HISTORIC AND DESIGN REVIEW COMMISSION

June 21, 2023

HDRC CASE NO: 2023-156
ADDRESS: 114 DEWBERRY ST
LEGAL DESCRIPTION: NCB 6461 (MISTLETOE ADDITION SUBDIVISION), BLOCK 1 LOT 57
ZONING: R-4, H
CITY COUNCIL DIST.: 1
DISTRICT: River Road Historic District
APPLICANT: Jim Tafoya/BRIO BUILDERS
OWNER: DANIEL & STEPHANIE PINA/PINA DANIEL & STEPHANIE
TYPE OF WORK: New construction of a two-story house
APPLICATION RECEIVED: May 18, 2023
60-DAY REVIEW: July 17, 2023
CASE MANAGER: Jessica Anderson

The applicant requests a Certificate of Appropriateness for approval to construct a two-story residential structure on the vacant lot at 114 Dewberry.

SHEET: **A-2**

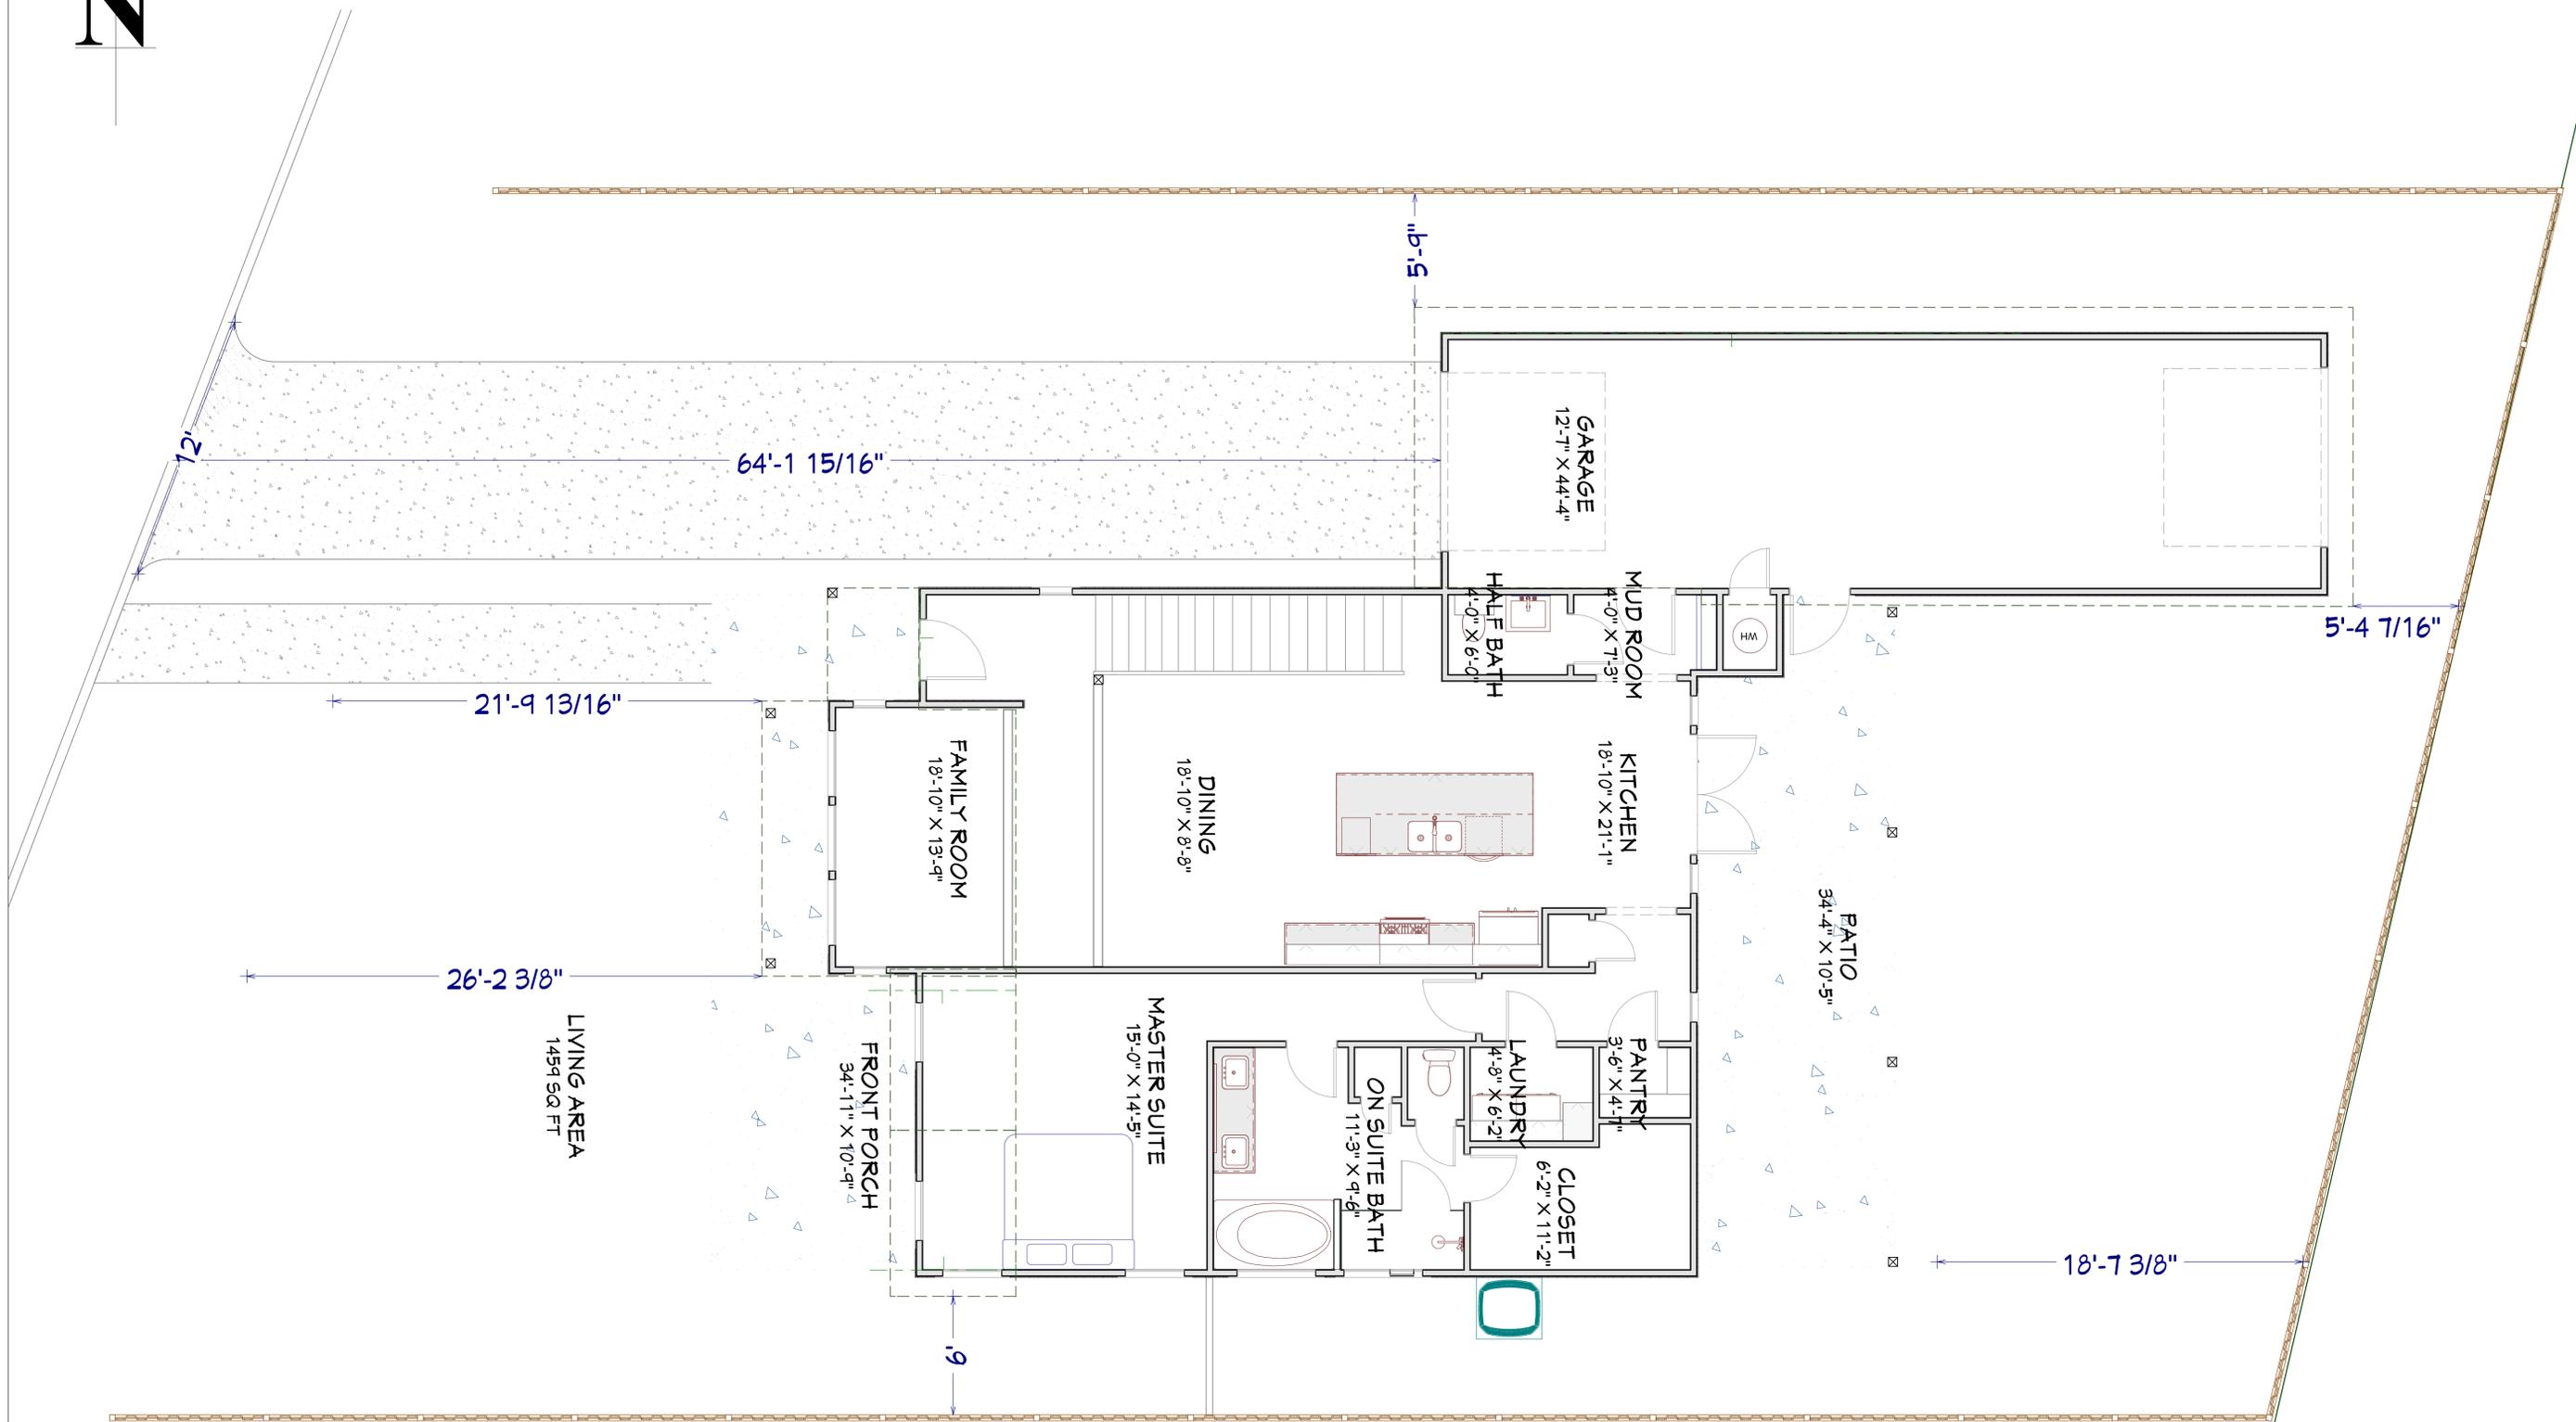
Savino: Show trees—existing or proposed—show the diameter if it's an existing tree. It gives us an idea of what the canopy is like. I'm wondering in reality when a house this size is built, there's a real good chance that tree isn't going to survive. It's so hard to keep a tree. If we can understand your design and intention with tree, tree coverage, placement relative to the plan, that would be helpful to all of us. Often times trees come down during construction whether we plan to or not. Re the tandem garage: remind me why it is a tandem with a door on the other side.

Applicants should consider decoupling the garage and continue working on overall massing. Windows were an improvement from last iteration. Applicants should include existing and planned trees on site plan.

Longoria: Landscaping plan will include canopy of trees on neighbor side. We'll make sure to have that updated so we can show trees we have on site.

SHEET: A-6

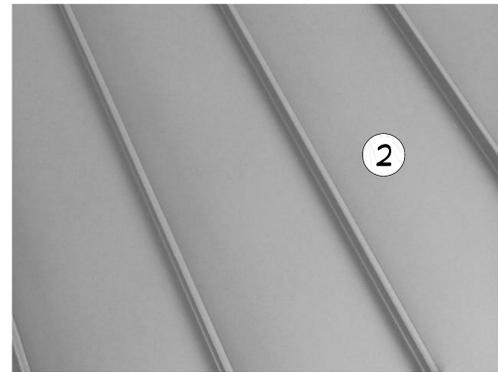
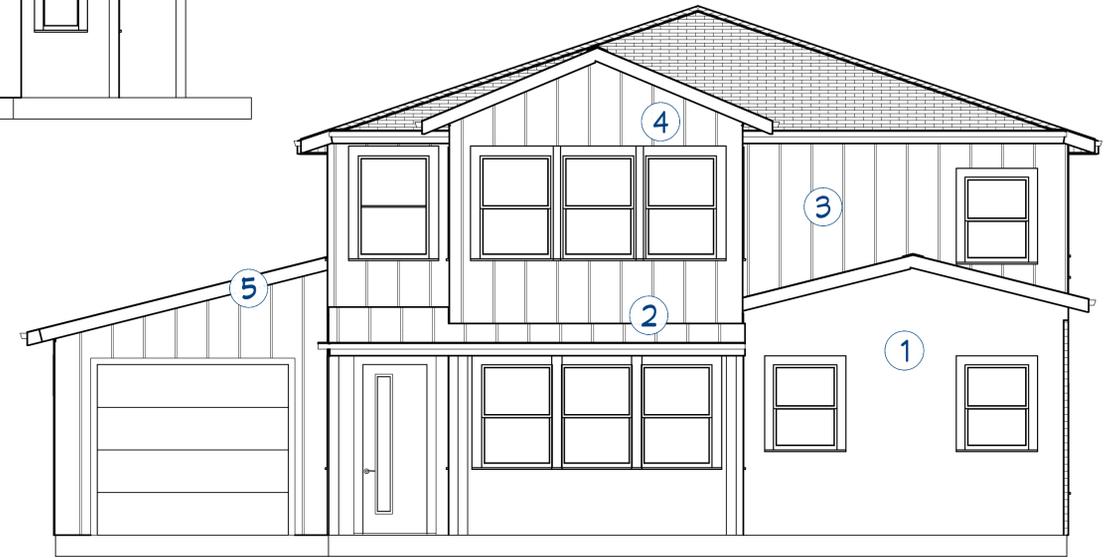
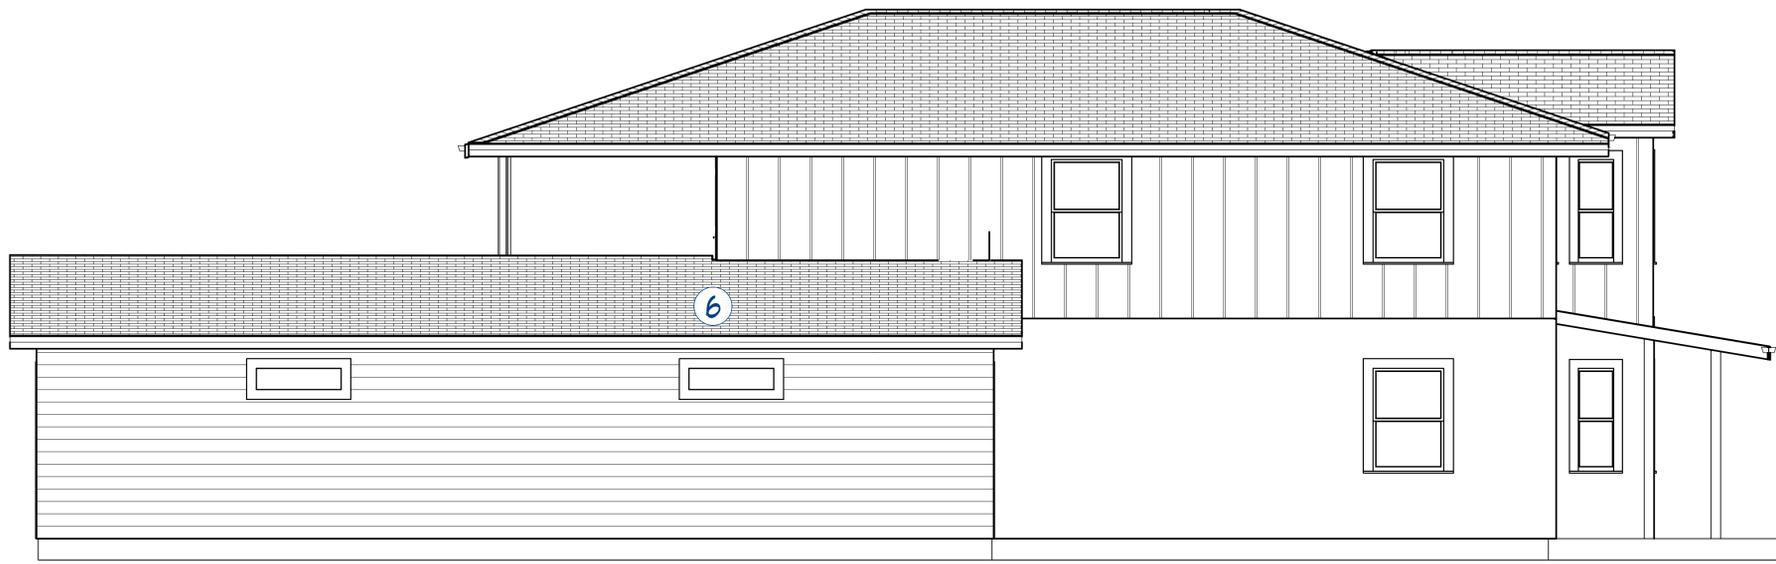
Grube: This can be presented at the meeting. Now let's talk about fenestration. Normally don't find a whole wall of windows. Rectangular on front to the right are not found. We were hoping to see some changes in the plan. We can't take all examples from one house on Craig. Yes, location might be taken into consideration, but overall this is not a common fenestration pattern in this neighborhood.

Savino: Why are the square windows not able to be single or double hung, similar proportions to the upstairs? Nothing in the plan dictates that location.

Mazuca: So you've got some light in your stairway. The hipped roof is an improvement. I like the change of fenestration in the front.

Savino: Continue roof and align it with the front piece, especially since you changed the front bedroom roof to a front-facing gable. You eliminated that roof piece. If you continue the roof from the entry over, you're unifying those volumes. There's not a lot connecting them.

Windows have improved on the primary elevation, but commissioners voiced concerns about window types and windowless spaces on other elevations. Hipped roof form is an improvement. Consider modifying the front porch awning so that it's a single plane.

- vii. That the applicant amends the proposed fenestration profile to incorporate windows that feature a one over one profile rather than the fixed clerestory windows proposed, as noted in finding m.
